UNITED STATES
NUCLEAR REGULATORY COMMISSION

This is to inform you of the disposition for traveler TSTF-373, Revision 1 containing proposed changes to the improved Standard Technical Specifications (ISTS), initiated by the NEI Technical Specification Task Force (TSTF). TSTF-373, R.1 will require modification.

The staff has reviewed traveler TSTF-373, R.1 which proposed extending the allowed outage time for containment isolation valves from the current 4/72 hours to 7 days in NUREG-1432, STS 3.6.3. Comments and a staff markup of the appropriate specification that may be useful for possible modification of TSTF-373, R.1 are enclosed.

Staff Comments on TSTF-373 Revision 1

Insert A (Continued)

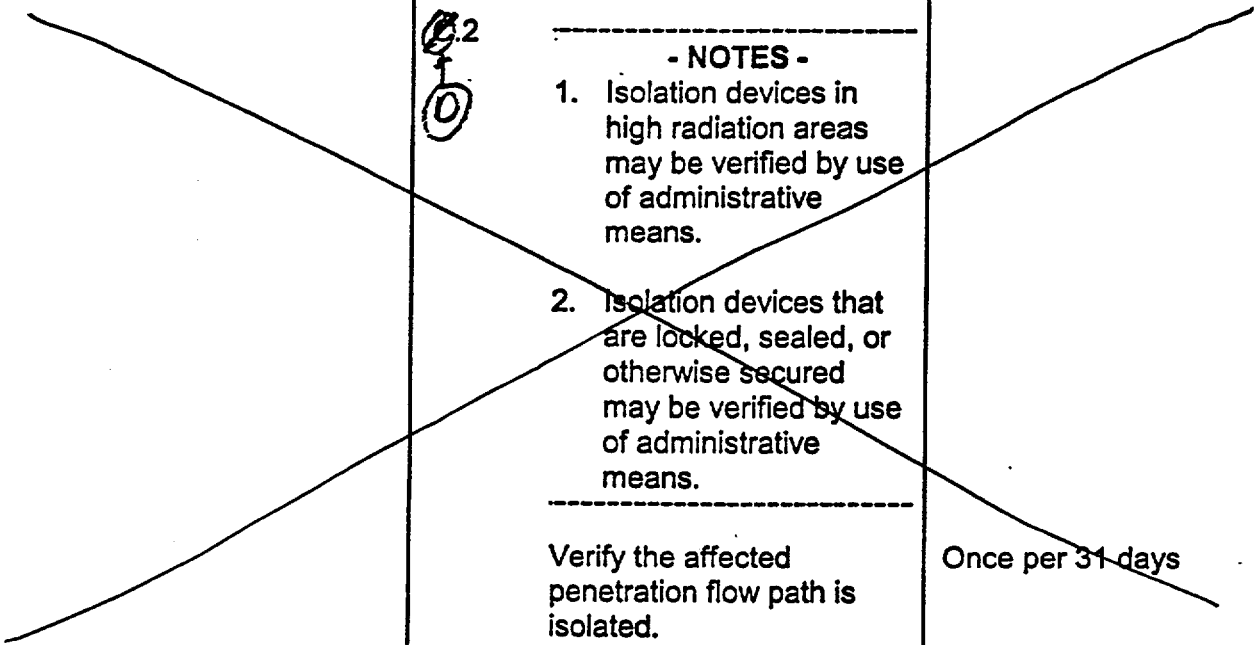
3. The response to Comment 3 for TSTF-373 Revision 0 is incomplete. The proposed Revision 1 change would be acceptable if all the CIVs covered by Condition D had only one Completion Time either 72 hours or 7 days. However, the TSTF needs to address the condition where some of the Condition D CIVs meet the 7 day criteria and some do not, similar to what is proposed for Conditions A and B (see Comment 2 above). Either two separate actions need to be developed or one action in a format similar to NUREG-1433/1434 BWR 4/6 STS 3.6.1.3 Condition C. See attached markup.

CONDITION	REQUIRED ACTION	COMPLETION TIME
<p data-bbox="201 359 553 667">E. ----- Only applicable to penetration flow paths with only one containment isolation valve and a closed system. That do meet the 7 day Completion Time criteria. ----- One or more penetration flow paths with one containment isolation valve inoperable.</p>	<p data-bbox="623 359 1005 596">E.1 Isolation the effected penetration flow path by use of at least one closed and de-activated, automatic valve, closed manual valve, or blind flange.</p> <p data-bbox="623 638 683 667"><u>AND</u></p> <p data-bbox="623 709 980 739">E.2 -----</p> <p data-bbox="743 741 878 770">- NOTES -</p> <ol data-bbox="688 812 1005 974" style="list-style-type: none">1. Isolation devices in high radiation areas maybe verified by use of administrative means. <p data-bbox="688 1016 1013 1213">B. Isolation devices that are locked, sealed, or otherwise secured maybe verified by use of administrative means.</p> <p data-bbox="688 1255 1005 1350">----- Verify the affected penetration flow path is isolated</p>	<p data-bbox="1040 359 1146 388">[7 days]</p> <p data-bbox="1040 1255 1284 1285">Once per 31 days</p>
